---

**AGENDA ITEM SUMMARY / STAFF REPORT****ITEM NO:** 5**FLORENCE PLANNING COMMISSION**Meeting Date: December 12, 2023

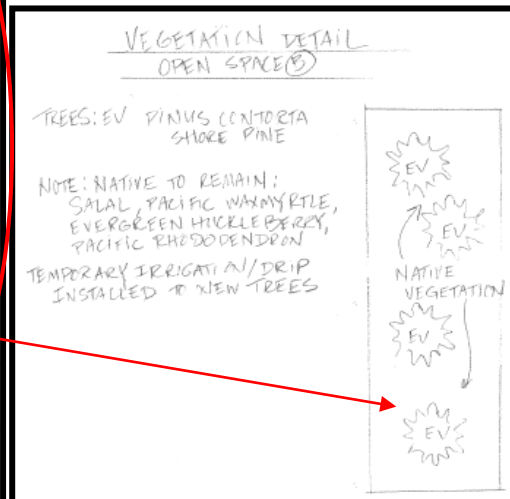
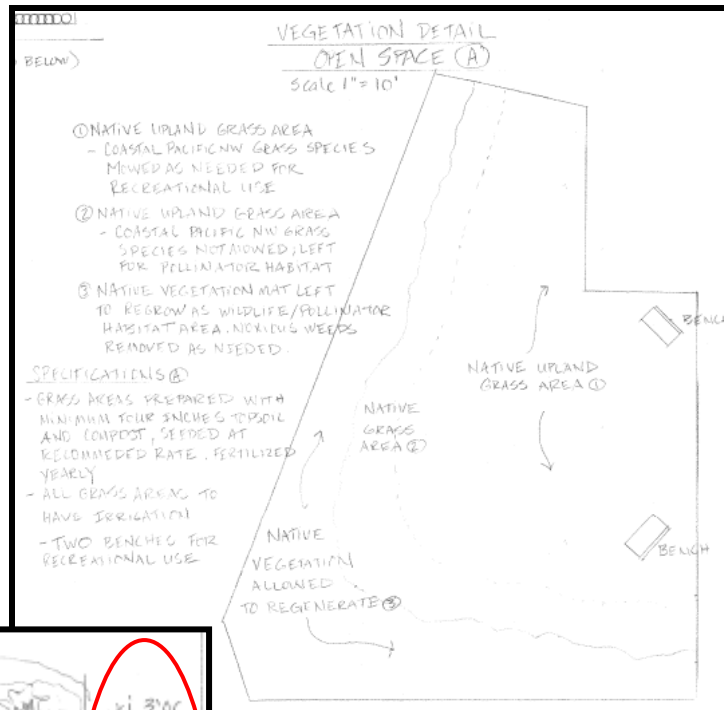
A statement in the Addendum to Myrtle Glen PUD Addressing NOIC (Exhibit G) states:

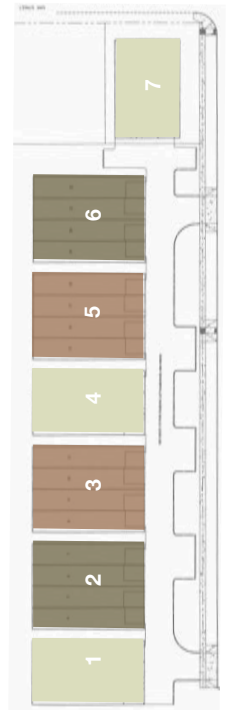
Myrtle Glen Subdivision  
Final PUD Application to City of Florence - Addendum 1  
October 16, 2023
